SUBJECT: Savannah River Site's Responses to the Regulatory Comments on the Groundwater Report for the P-Area Groundwater (PAGW) Operable Unit (OU) (U) April 2021 through March 2022 Data (SRNS-RP-2022-00963, Revision 0, January 2023) SEMS Number: 81

SRS Responses to USEPA Comments on the Groundwater Report for the P-Area Groundwater
(PAGW) Operable Unit (OU) (U)

April 2021 through March 2022 Data SEMS Number: 81

SRNS-RP-2022-00963, Revision 0, January 2023,

Figure CR-1.

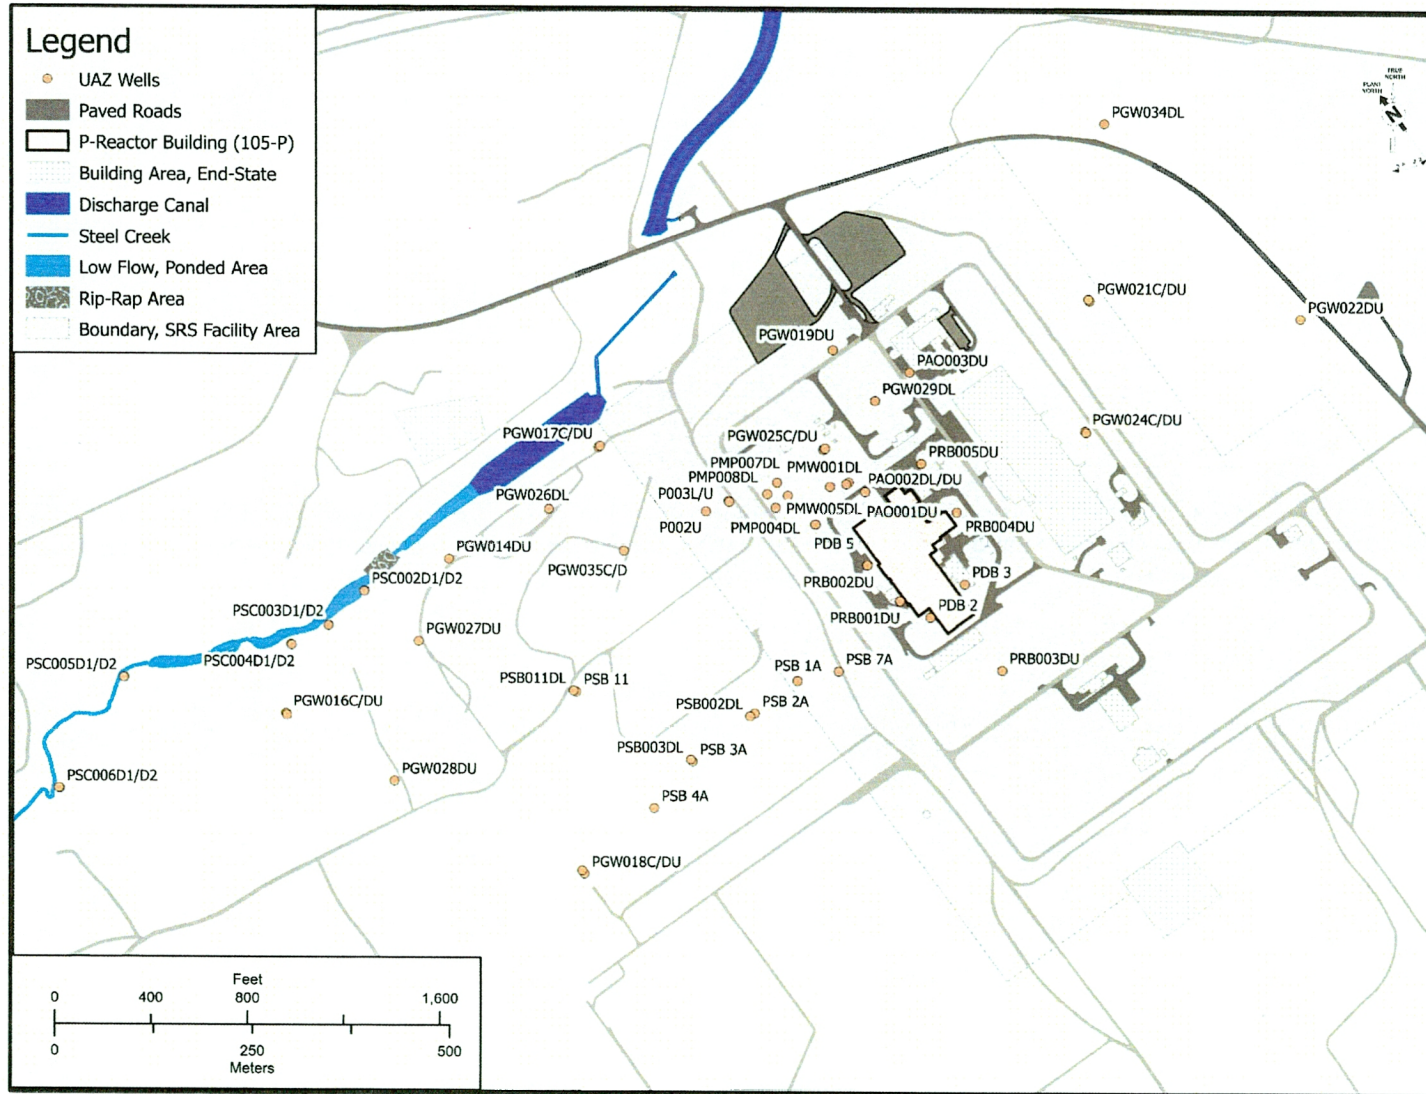
2. There is a grey patterned box symbol depicted on multiple site figures that is not defined in the respective figure legends. For example, the grey patterned box is depicted on Figure 7 (Monitoring Well Network for the Upper Aquifer Zone, Page 28 of 100) near upper aquifer zone (UAZ) well PSC002D1/D2, on Figure 8 (Monitoring Well Network for the Lower Aquifer Zone, Page 29 of 100) near LAZ well PGW014C and at a similar location in Figure 9 (Monitoring Well Network for the Gordon Aquifer Unit, Page 30 of 100); however, the symbol is not defined in the legends. This omission is also found on Figures 15, 16, 17, 18, 23, 26, 28, 31, 32, 38 and 42. In addition, Figure 30 (Steel Creek Sampling Access Road completed in January 2023, Page 58 of 100) shows the constructed Steel Creek Sampling Access Road; however, it is unclear whether the gray patterned box symbols shown on the noted figures represent the newly constructed access road. *Please revise the figure legends to define the grey patterned box symbol.*

SRS agrees that the grey patterned shape is not defined in figures for the 2022 groundwater monitoring report. This shape depicts a rip-rap feature in the Steel Creek

discharge canal. The shape will be defined in future PAGW OU groundwater monitoring report figures as shown in Figure CR-1.

Figure CR-2.

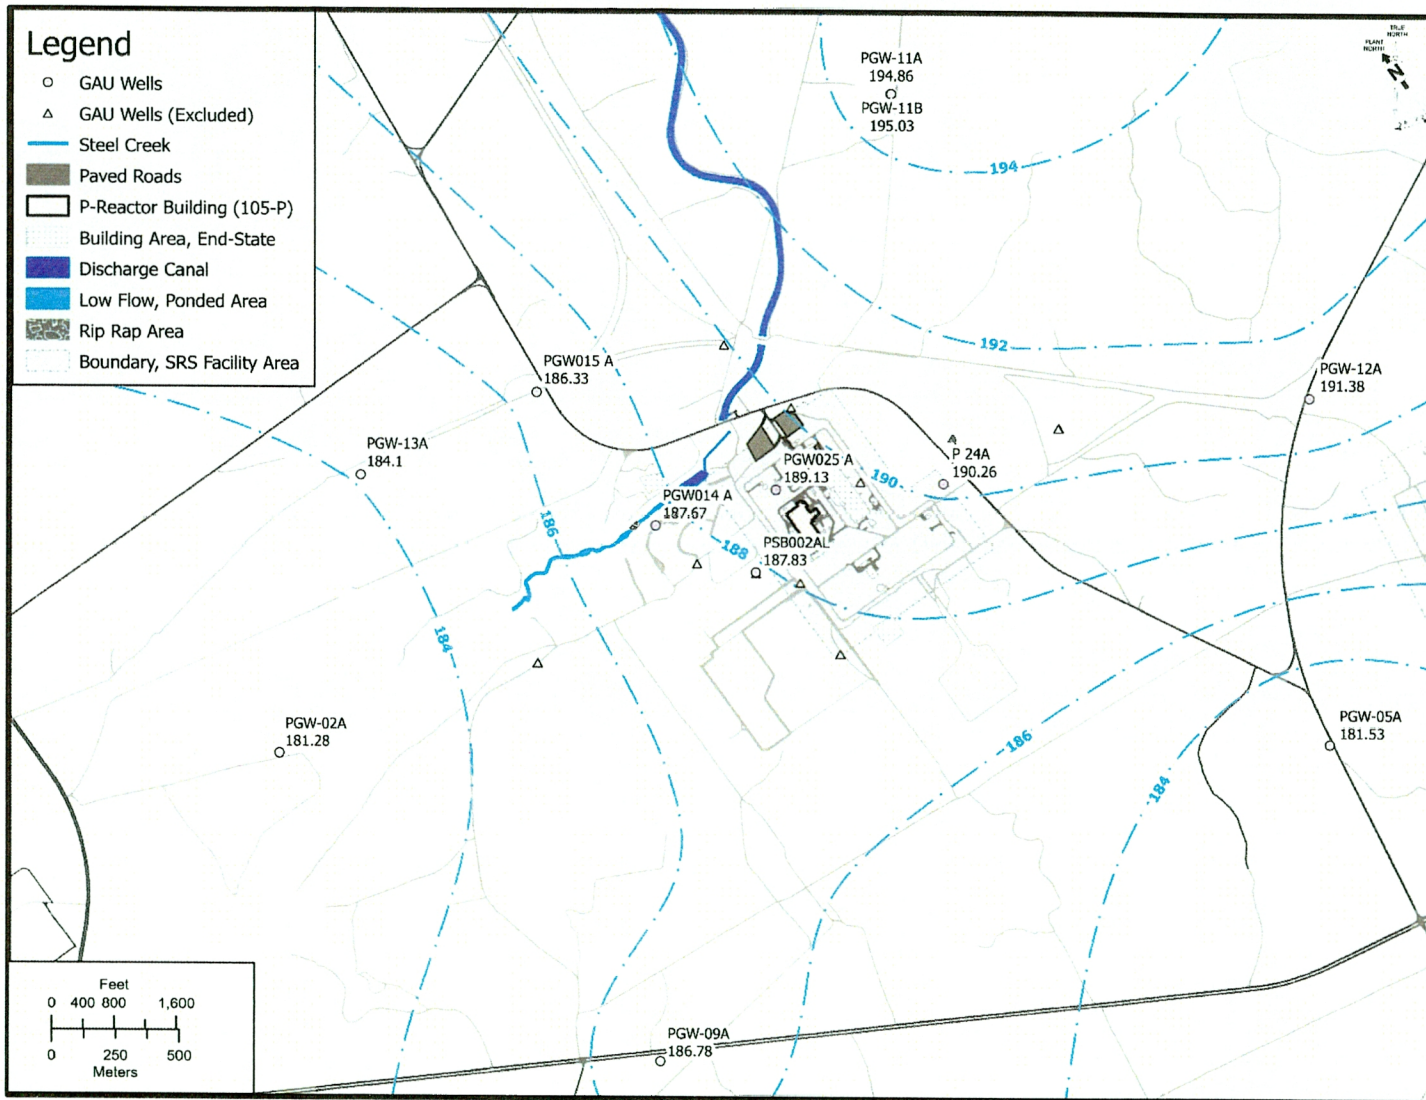
1. **Section 3.2, Groundwater Elevation Measurements and Groundwater Flow Direction, Page 7 of 100:** The last paragraph indicates that certain wells are excluded from the well elevation data due to being dry or obvious outliers; however, this section does not state the number of wells or identify which wells were excluded. *Please revise the text to list the wells that were not included in the well elevation data.*

SRS agrees that the stations excluded from potentiometric contour calculations were not listed in this section. The excluded stations will be included in the figures, depicted by a unique symbol for future reports as shown in Figure CR-2. The excluded station IDs will be identified in Table 2 with highlighting and a note, as shown in Table CR-1.

Figure CR-3. 2018 LAZ TCE Plume and Potentiometric Surface with SAP Locations, Wells, and Surface Water Locations

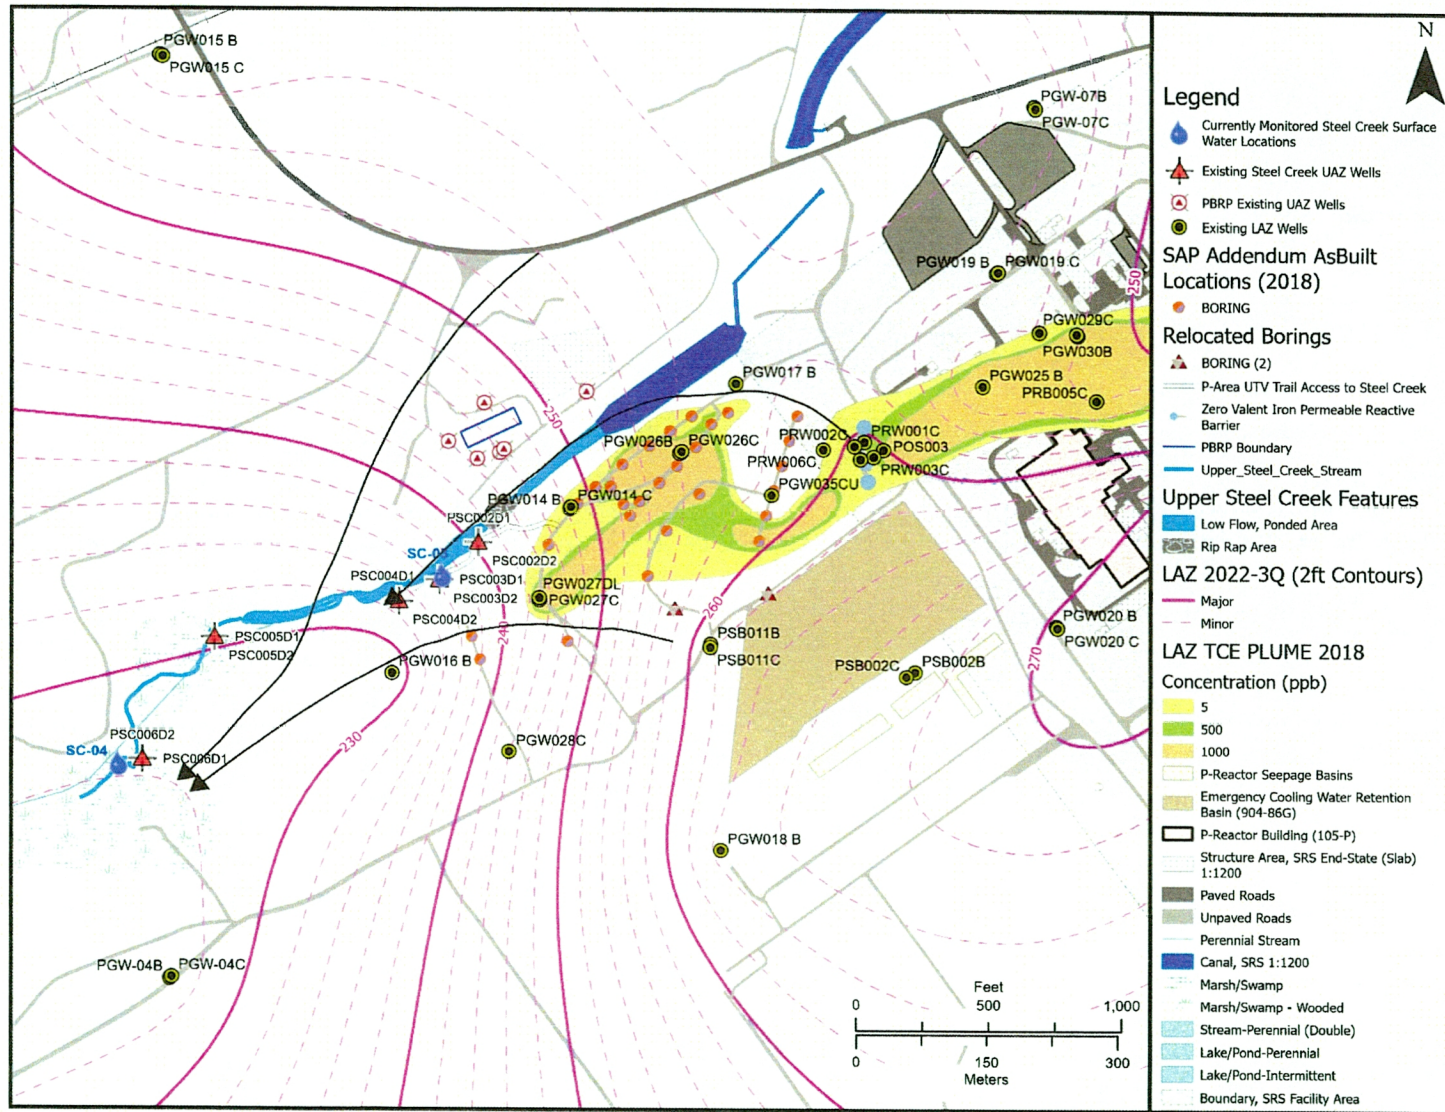
6. **Section 3.3.2.2, Lower Aquifer Zone, Pages 14-15 of 100:** The text states “TCE migration horizontally in the LAZ is parallel to upper Steel Creek and therefore is not anticipated to discharge to surface water in the near term”; however, LAZ data from monitoring locations across from, and to the north of, Steel Creek are not presented to support the assertion that migration in the LAZ is parallel to Steel Creek. As such, it is unclear if TCE contamination is migrating to the north, below Steel Creek. *Please revise the text to discuss how potential TCE contamination migration to the north across Steel Creek is being assessed.*

The area in the vicinity of Steel Creek has undergone numerous characterization activities over the years with the most recently completed 2018 investigation in support of the PAGW Sampling and Analysis Plan Addendum (SRNS-RP-2018-00261). Outcome of that work was provided in the 2020 PAGW EMR (SRNS-RP-2020-00621) and presented to the Core Team in July 2020 (SRNL-L3220-2020-00009). In summary, the findings of the work determined that the LAZ groundwater plume is limited in extent and does not discharge to the upper reaches of Steel Creek based on elevation of measured contamination within the aquifer and surface water elevations. The plume continues to migrate along groundwater flow direction that parallels Steel Creek in a west-southwest direction. Based on the potentiometric surface and surface elevations, it is expected that discharge of LAZ contaminated groundwater might first be detected

further downgradient at surface water location SC-04 and shallow wells PSC006D1 and PSC006D2 (Figure CR-3). Previous groundwater modeling supports this assertion (SRNS-RP-2015-00768). Currently, no contamination is observed at PSC006D1 or PSC006D2. Surface water location SC-04 has sporadically reported detections of TCE; however, these concentrations have been observed at, or below, 1 ug/L. The 2018 investigation determined that the detection of TCE at this location was from the discharge of the UAZ TCE groundwater plume at surface water location SC-03 and subsequent flow downstream until volatilization and/or dilution of TCE brought levels below detection.
